# TECHNICAL NOTE TN-1189 TB8100 VCO Out of Lock Alarms

21 June 2006

TB8100 400 to 520MHz (H1, H2 and H3 band) Reciters using RF PCB 220-02025-08.

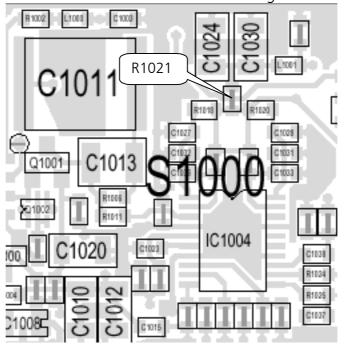
On the RF board, remove the screening cans shown below.

Change R1021 and R1124 from 100 Ohms to 47 Ohms. Tait part 038-12470-00, RES 0603 47R 5% 1/10W.

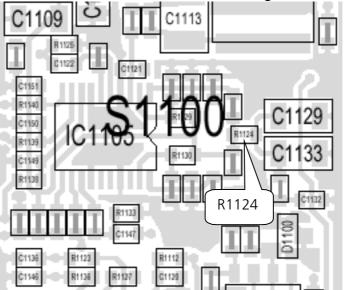
Locate R1021in the RX VCO and change to 47 Ohms.

RX VCO schematic showing the location of R1021. TX VCO schematic is the same, component designations differ.

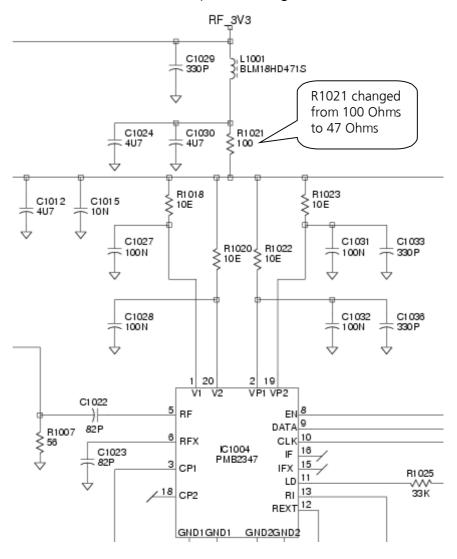
Locate R1124 in the TX VCO and change to 47 Ohms.
